DUKE COGEMA
STONE & WEBSTER

8 March 2002
DCS-NRC-000085

Subject: Docket Number 070-03098
Duke Cogema Stone & Webster
Mixed Oxide Fuel Fabrication Facility
Construction Authorization Request
Clarification of Responses to NRC Request for Additional Information

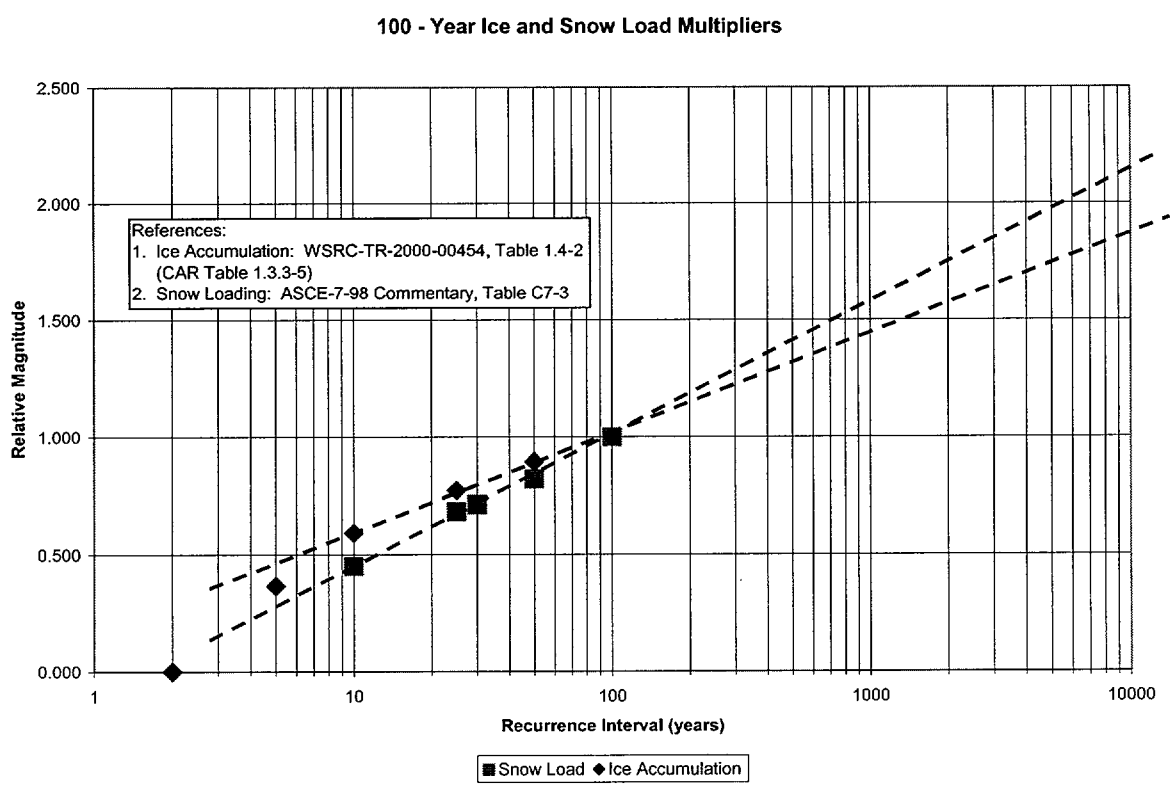
In response to RAI 56, DCS stated that it selected a 100 year recurrence interval for snow loading. Chapter 1 in the CAR states that a 100 year recurrence interval snow load corresponds to 5 pounds per square foot (psf). NRC staff requested that DCS consider a snow load recurrence interval for more than 100 years (i.e., on the order of 10,000 years). Since the larger snow load is an extrapolation of snow loads having a lower recurrence interval, NRC staff also questioned whether the appropriate 100 year snow load should be 5 psf or 10 psf, since the MOX site lies on a boundary in the map included in the American Society of Civil Engineers (ASCE) Standard 7-98 Figure 7-1, "Ground Snow Load for the United States."

DCS stated that it had considered a larger recurrence interval and that the snow load associated with this larger interval is bounded by the roof load chosen for design. DCS will provide information to support this statement. DCS provided a more accurate map

showing that the MOX site lies in the 5 psf snow load zone in ASCE 7-98. NRC staff acknowledges that for the MOX site, the ASCE 7-98 Figure 7-1, "Ground Snow Load for the United States," shows that the snow load to be considered is 5 psf. {28 February 2002, item 2D}

As stated in Section 1.3.3.3 of the CAR, the maximum ground snow load for the SRS area for a 100 year recurrence period is estimated to be 5 psf. The source of this information is ANSI A58.1-1982, *Building Code Requirements for Minimum Design Loads in Building and Other Structures*, the predecessor to the current ASCE-7-98, *Minimum Design Loads for Building and Other Structures*. A review of Figure 7-1 in ASCE-7-98 shows that the ground snow load for the SRS is 5 psf for a 50-year mean recurrence interval. Converting this value to a 100-year mean recurrence interval using the factors shown in Table C7-2 results in an estimated ground snow load of about 6 psf. When this is combined with the estimated 3 psf ice loading described in CAR Section 1.3.3, the specified 10 psf combined ice and snow design basis loading for a 100 year recurrence period is still appropriate.

To reflect the more recent estimate of snow load, the last sentence in the second paragraph of CAR Section 1.3.3.3 will be revised to read "The maximum ground snow load for the SRS area for a 100-year recurrence period is estimated to be 6 psf."

The following text will be added at the end of CAR Section 1.3.3.3: "Such highly unlikely snow and ice roof loads are not combined with roof live loads from other sources in the structural evaluations described in Section 11.1 of the CAR."

Snow and Ice Loads - Revise this section to read, "The combined snow (S) and ice (L) design load is 10 psf, as defined in Section 1.3.3.3. This load is applied concurrently with the roof live load specified in the above table."
